FIELD CHANGE DIRECTIVE
No. 10-Rev. 1

PROJECT: Truman Waterfront Park Phase 1A

FCD-10 Hardscape Revisions

August 22, 2016

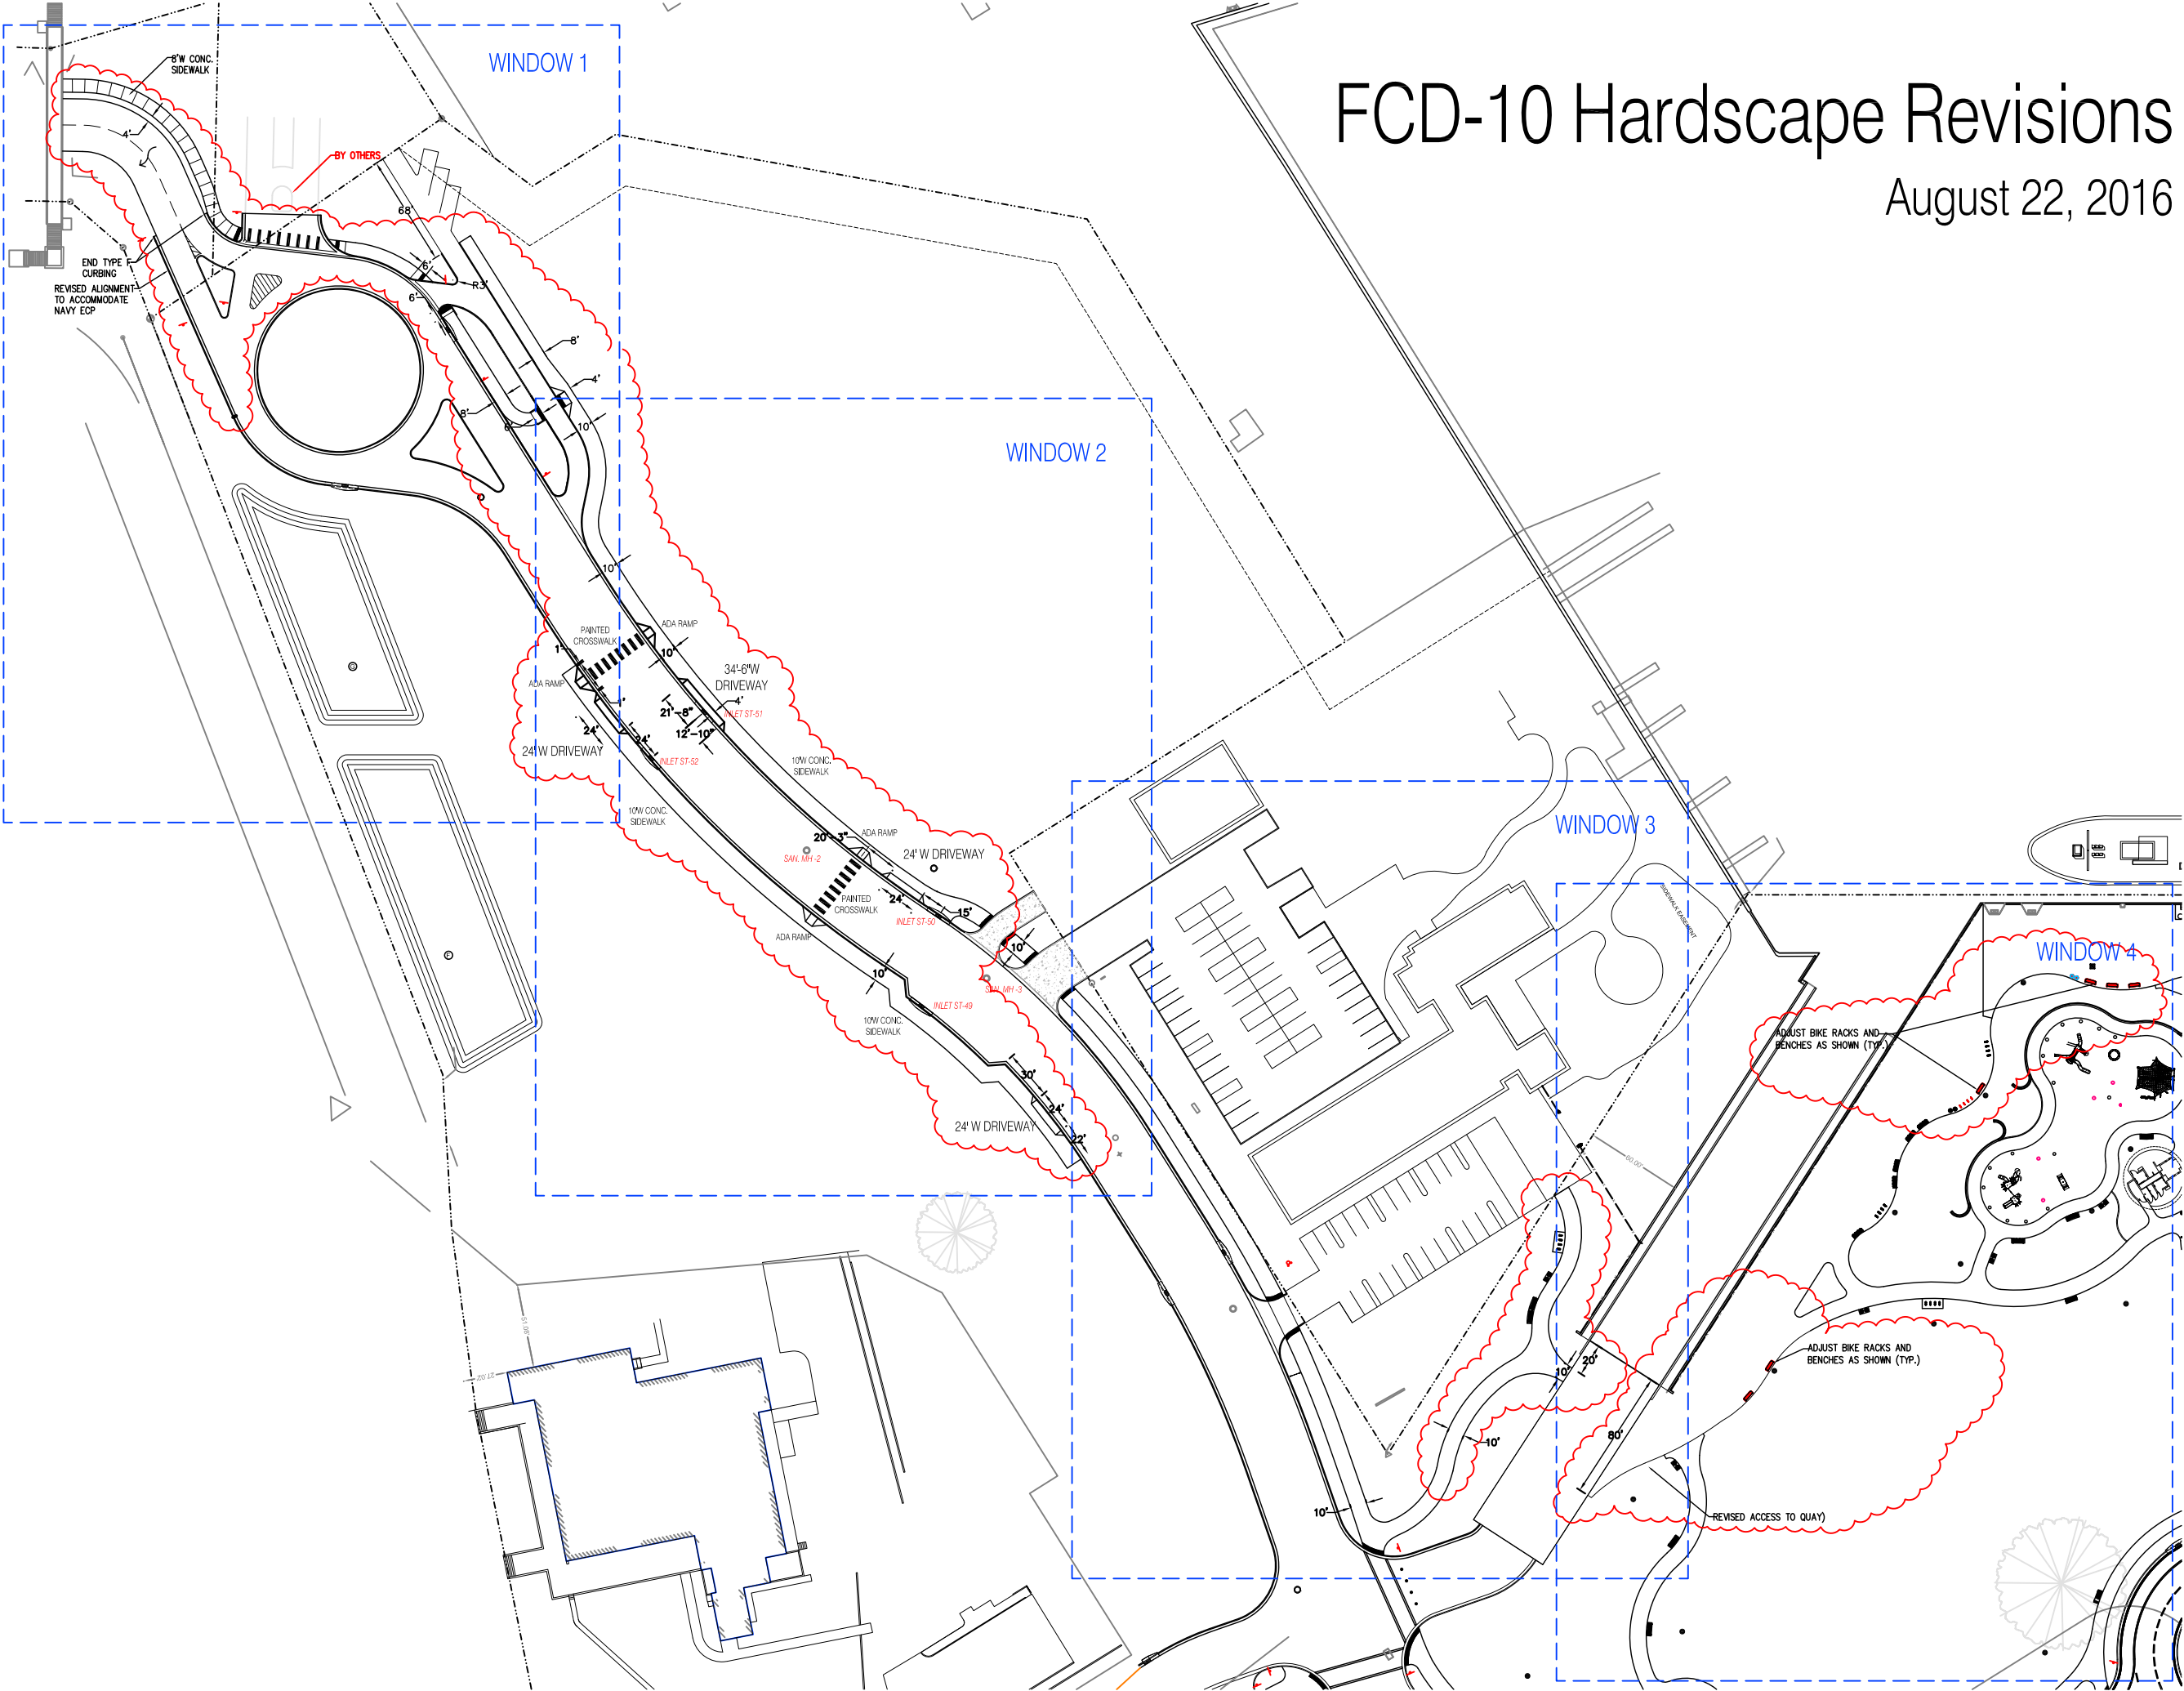
1. Upsized 6" SS lateral to 8"
2. Upsized lateral relocated to other side of ST-51
3. Install three (3) 8x8 clean out assemblies added for 8" SS laterals (prior 1 was a 6" lateral per plan)

4. Keys Energy high voltage duct bank conflict Add +/-100' FM to relocated SSMH 1; Delete +/-100 LF of Sanitary Sewer main.
5. Valley Inlet modification added to ST-51

6. Relocation of soils stockpile from Parcel C [N/C] +/- 250'-0" Silt fencing (to be confirmed) added to Parcel K stockpile for Amphitheater berm
7. CKW authorized (1) soft dig for Keys duct bank

8. Formwork install / removal at Fort Zachary Taylor Park entrance
9. Add sidewalk, two (2) ADA curb ramps and two (2) driveways on plan left (south)side

10. Move sidewalk to curb and Add two (2) ADA curb ramps and two (2) driveways on plan right (north) side
11. Delete Bus Stop on plan right (north) side

12. Add trench undercut / install #4 rock trench stabilization from SSMH 5 to SSMH 4; portion of distance to

SSMH 3; short distance beyond SSMH 3; from SMH 2 to SSMH 1.

13. Move pedestrian lighting to behind new sidewalk alignment adjacent to proposed amphitheater
14. Revise Fort Zachary Taylor Park entrance road alignment to accommodate Navy ECP facility
15. Clarify curbing at Outer Mole entry and place hold on curbing at Ft. Zachary Taylor Park entrance; Delete curbing from just beyond circle to Fort entrance / overhead pedestrian bridge.

WINDOW 1

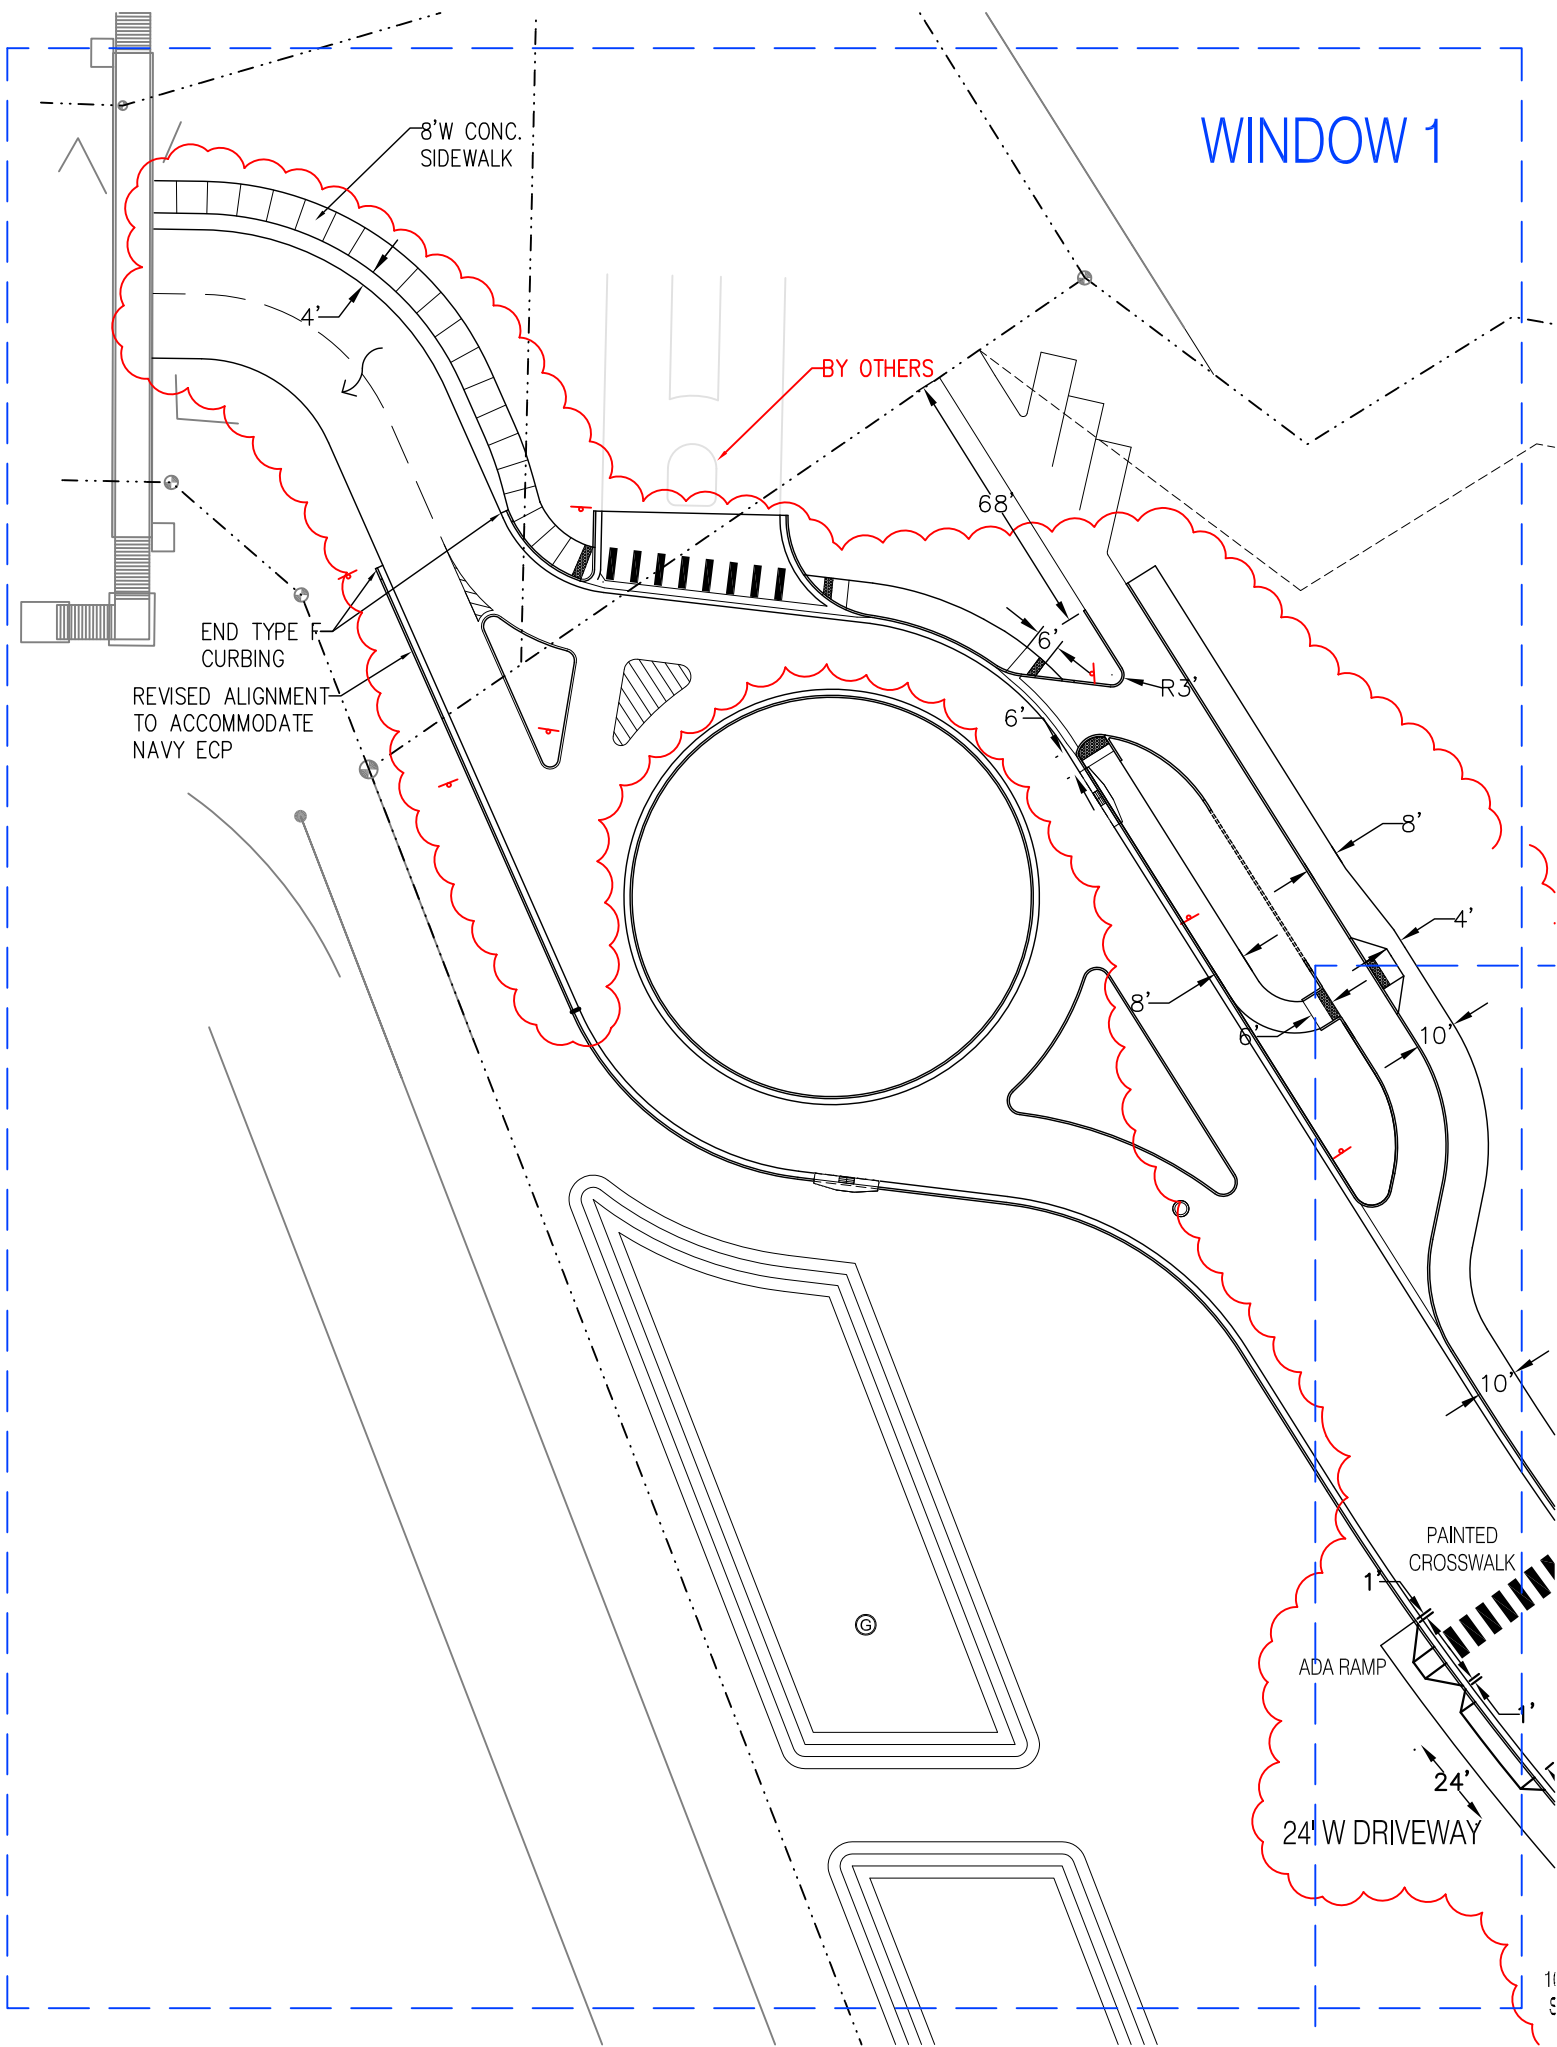
Incorporate sidewalk, curbing and East Quay Entry (at boat ramp) modifications as indicated on the attached Truman Waterfront Park Miscellaneous Hardscape Revisions dated August 22, 2016. Following review, provide City with any comments/questions, Requests for Information, and a Work Change Directive Proposal if so warranted.

WINDOW 3

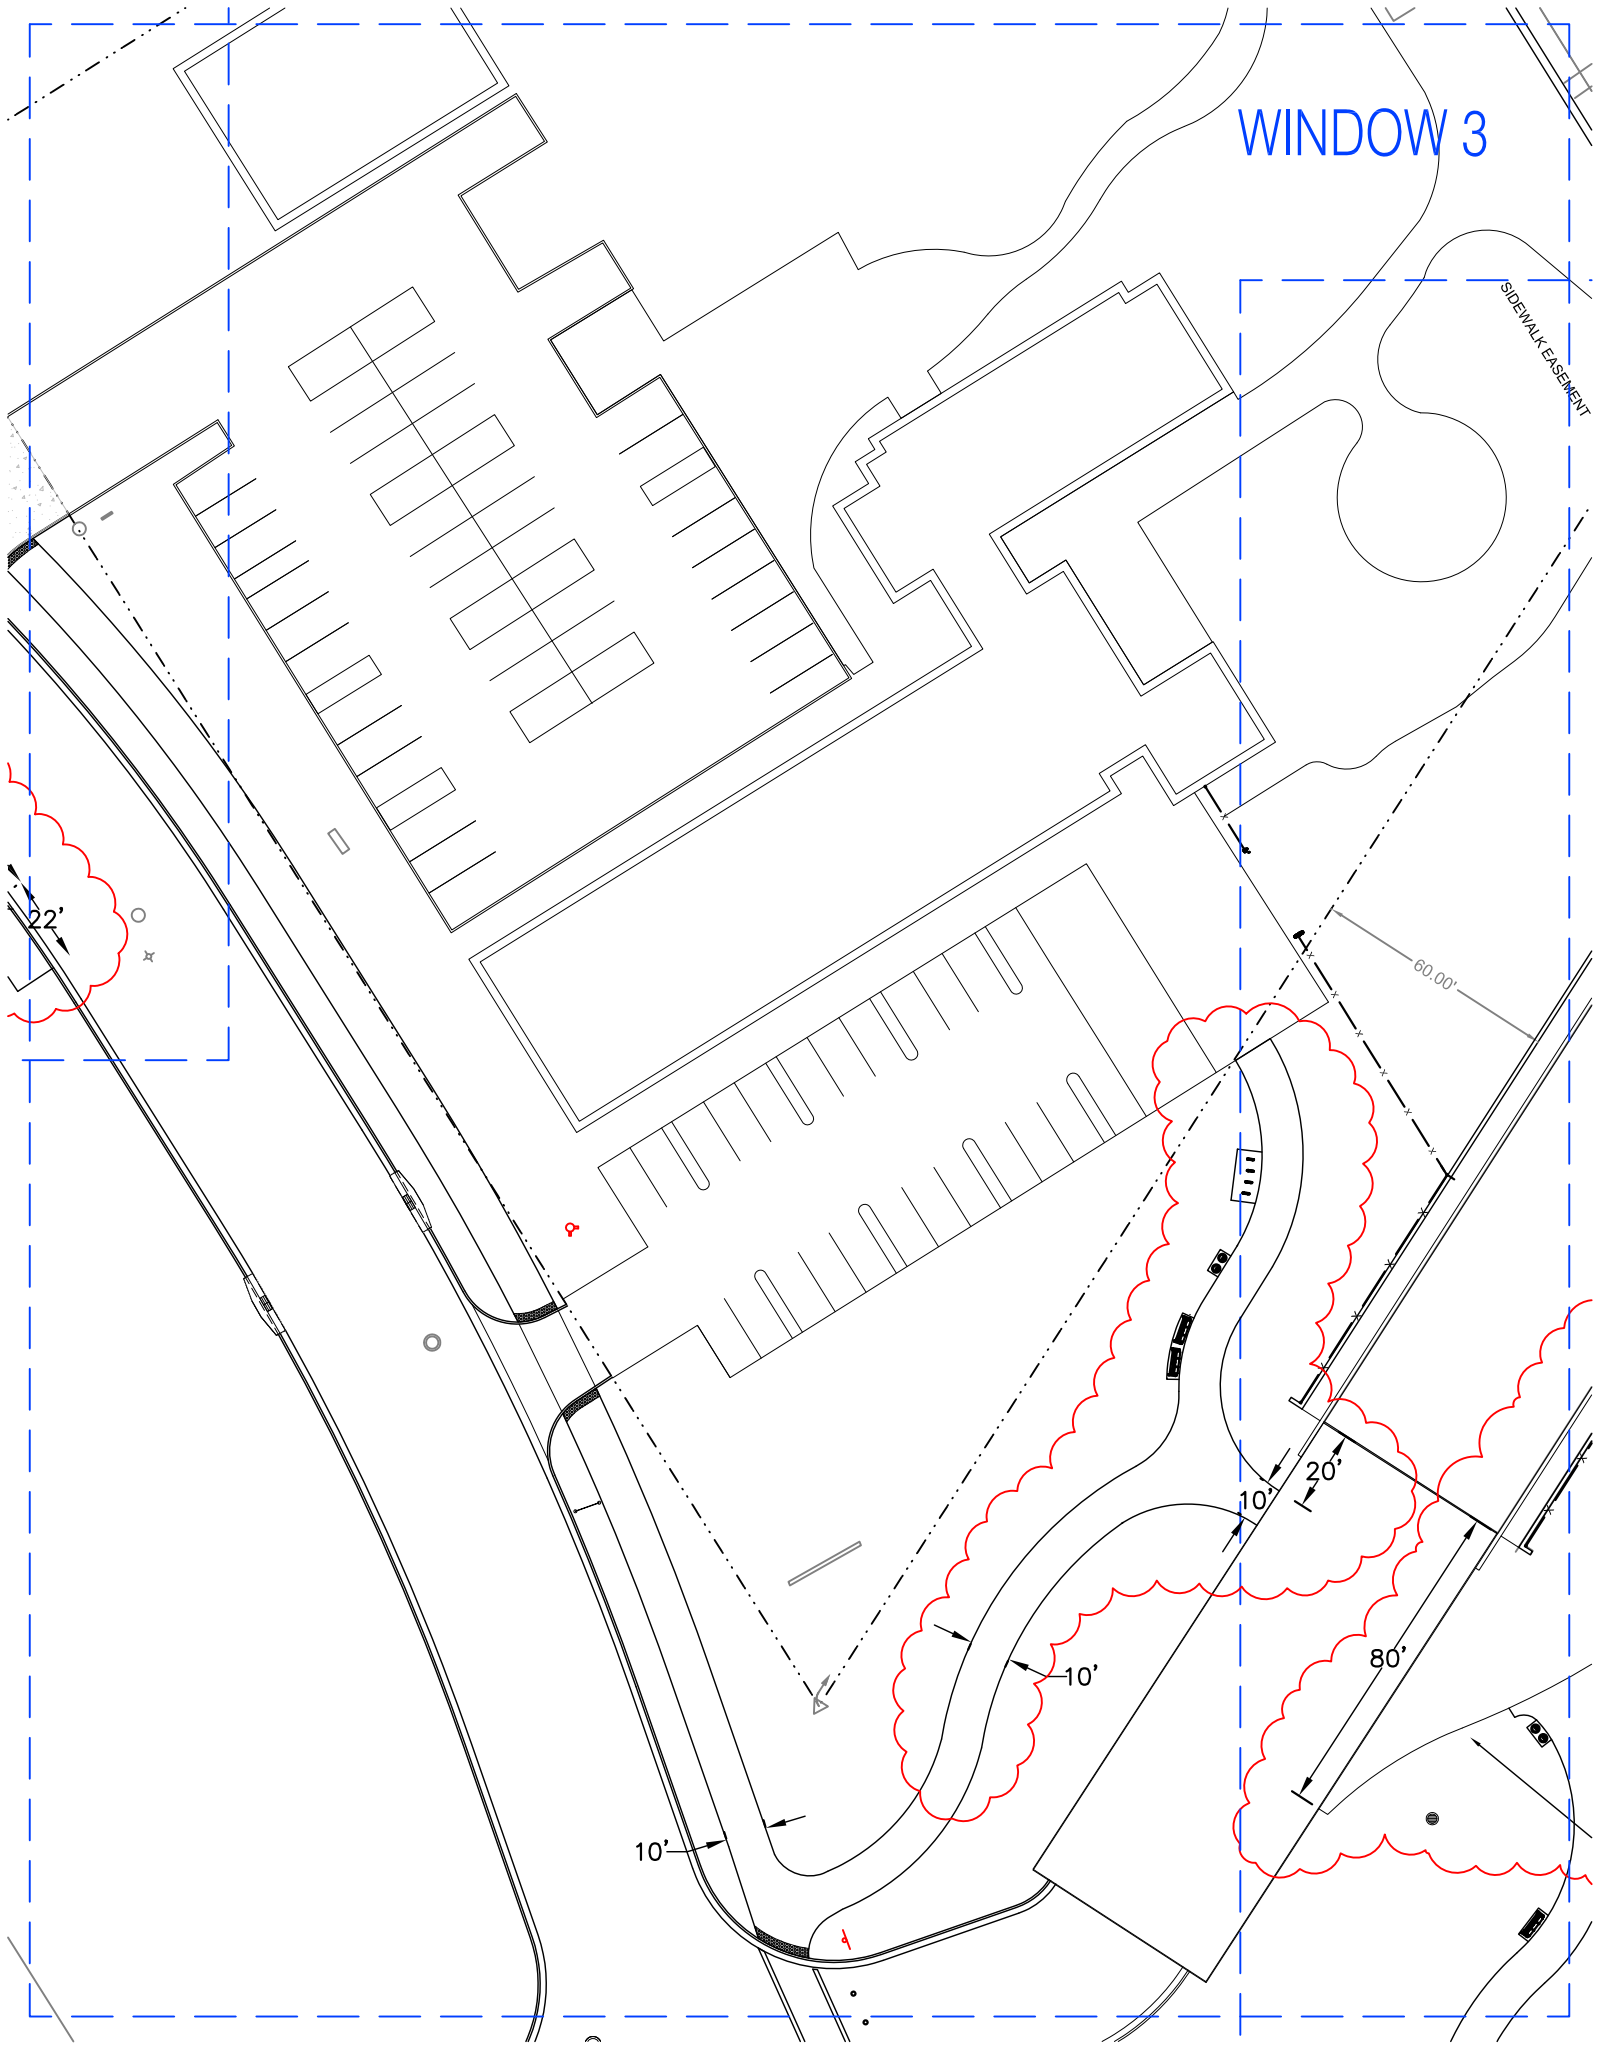
SIDEWALK EASEMENT
